Safety notice

Restricted use for Treatment chairs 500 XLE with serial numbers 2000-4506

Attachment to: Safety notice-Treatment chair 500 XLE-SN 2000-4506-27.04.2023

PROHIBITED - Critical patient positions!

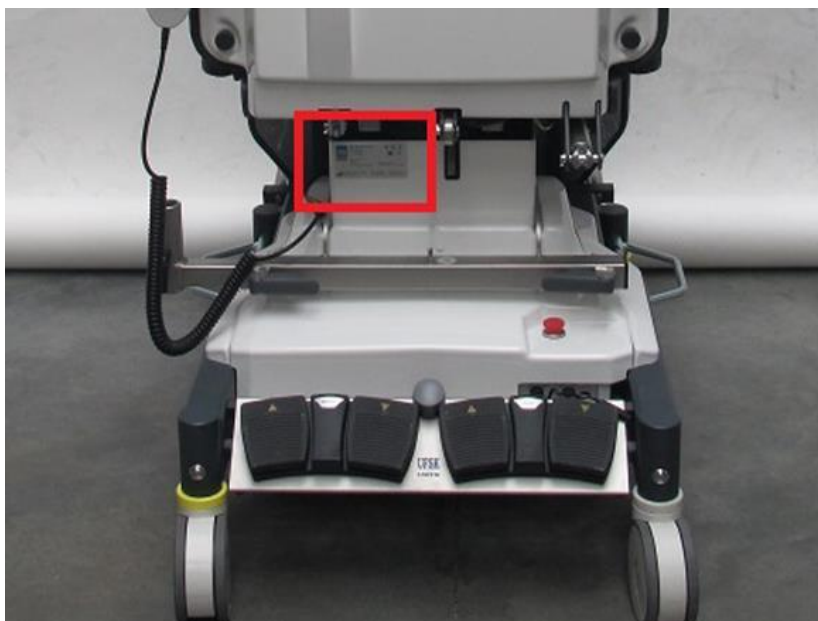
ATTENTION! The seat part must be in a horizontal position to the floor (see green cushion), the seat part drive remains in the retracted position (green marked component). Adjustment movements, e.g. into the reset position, are still possible (see adjustment positions of back and leg part shown in grey).

PROHIBITED! Tilting of the seat part by extending the seat part drive is prohibited. Memory positions that have been saved must be adjusted

ATTENTION - WORST CASE!

If the safe patient positions are not observed - in "worst case scenario" - this will cause the separation of the seat drive.

The seat part drive is retracted so far with the patient in position that the seat part is in a horizontal position; the seat part may no longer be adjusted with the positioned patient (see attachment: Illustration of safe and critical patient positions).
